HEARING REPORT

PRIVATE PLAN CHANGE 93 WARKWORTH SOUTH

KA WAIMANAWA LIMITED PARTNERSHIP AND STEPPING TOWARDS FAR LIMITED

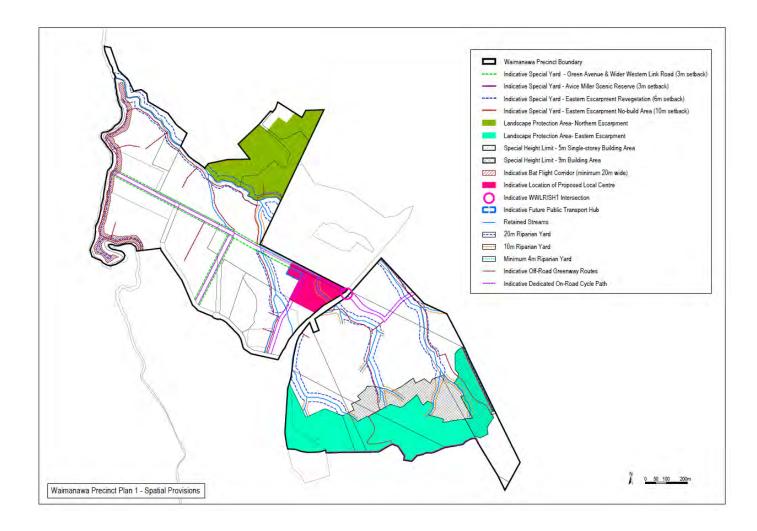
Remove the following information (which already appears on Precinct Plan 3):

- Indicative WWLR / SH1 Intersection
- Indicative Future Public Transport Hub
- Indicative Dedicated On-Road Cycle Path.

Ixxx.10.2 Waimanawa Precinct Plan 2 Environment

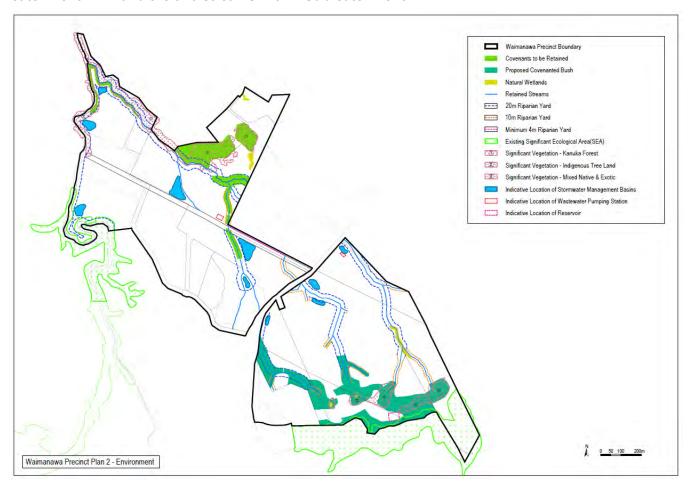
Amended to include a minimum of 10-metre riparian yard along the stream within Subcatchment XXXI and the two streams within Sub-catchment XXVII.

Ixxx.10.3 Waimanawa Precinct Plan 3 Transportation

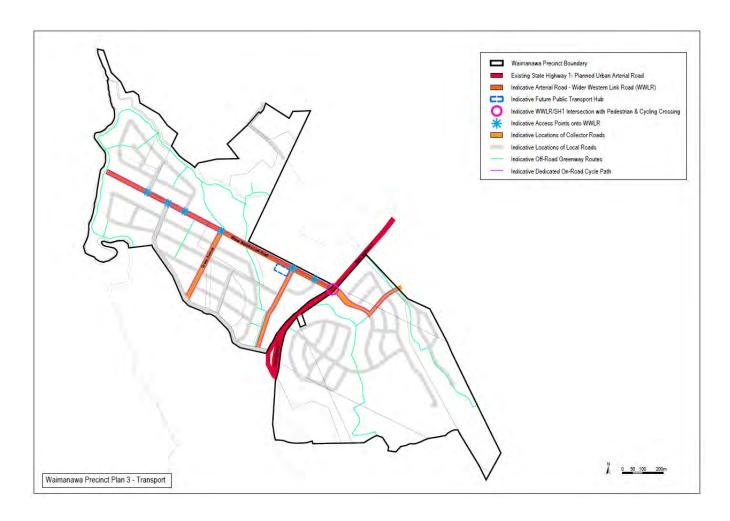
Amend Map 3 - Control: Arterial Roads, so it is clear that its purpose is to identify the Wider Western Link Road as an arterial road in the controls layer of the AUP(OP) map viewer. Delete from Map 3 the annotations for State Highway 1 and the indicative WWLR / SH1 intersection.
